Detailed Site Plan Discovery District

DSP-22024

STAFF REPORT

SUBJECT: Detailed Site Plan DSP-22024
Discovery District

Figure 3: East Elevation Showing Loading Space Entrance

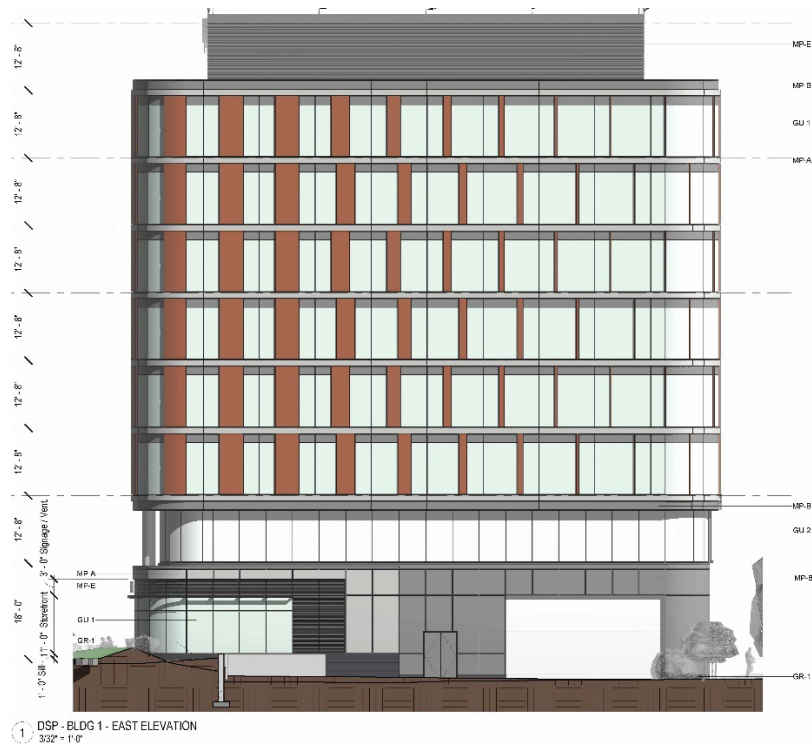
The loading area for the proposed development will be located internal to Building 1, to be accessed from Campus Drive. The loading area access will be minimally screened by 13 evergreen trees.

The applicant states in their SOJ that it is impractical to locate the loading area 30 feet away from the public sidewalk along Campus Drive. The loading area is currently proposed to be located in Building 1, with access from Campus Drive. The phasing plan on Sheet 1 of the DSP shows that Diamondback Drive, north of Testudo Way, will be removed prior to or concurrently with the completion of the intersection of Testudo Way and Campus Drive. A right-in/right-out turning lane at

Due to the curved geometry of the site and the building's proximity to Campus Drive at the rear, it is not feasible to locate the loading garage access 30 feet from the sidewalk. The landscape design incorporates a hedge to minimize the impact of the view to the garage as much as possible. Delaying parking lot screening in this phase should not substantially impair implementation of the plan. As a result of these reasons, staff recommend **approval** of these amendments.

Figure 5: Proposed Sign Types

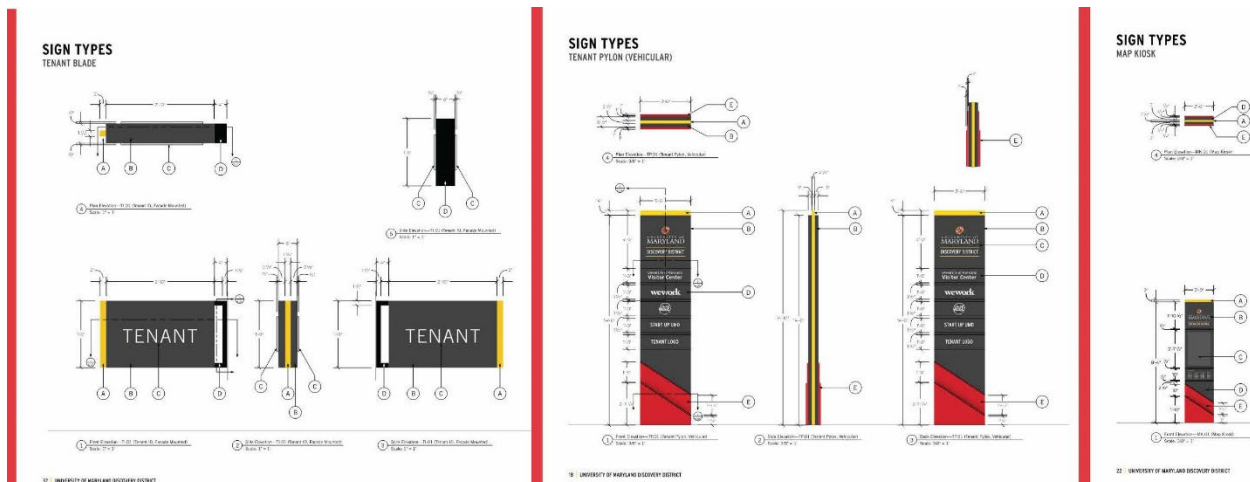
The applicant proposes a variety of signage types including tenant blade signs, tenant pylon signs, facade signs, window signage, map kiosks, and gateway pylon signs. All signage except for the wayfinding signs will be building-mounted. Building numbers are proposed to be visible from the internal plaza. The large “Discovery Point” identity signage at the top of Building 1 is currently designed with a maximum letter height of 5 feet, to provide for greater legibility given that the sign will be 126 feet above grade. A condition has been included herein, to provide signage detail for the “Discovery Point” sign, which is shown on the Building 1 elevation, but is not shown on the building signage sheet.

The submitted sign details for the project include the square footage for each sign type, but not all the details required to fully evaluate conformance with the sign requirements of the D-D-O Zone (page 254 of the sector plan). The maximum gross area of signs on a given façade shall not exceed 10 percent of the façade area of the commercial portion of the building, though architectural signs or signage painted on a building façade or mounted on the roof may exceed this limit, in certain cases. A condition has been included herein, requiring the applicant to demonstrate conformance with the applicable sign requirements.

- j. **Architectural Elements/Signage (page 254):** The sector plan states that a single external sign band may be applied to the façade of each building, provided that such signs shall not exceed three feet in height. The proposed development shows a surface mounted identity sign at the top of Building 1 with a maximum height of five feet. The increase in height for the signage is to provide greater legibility given the sign will be mounted 126 feet above grade. Staff find that given the placement of the sign at the stated elevation, the proposed letter height is appropriate and should not substantially impair implementation of the plan. As a result of these reasons, staff recommend **approval** of this amendment.
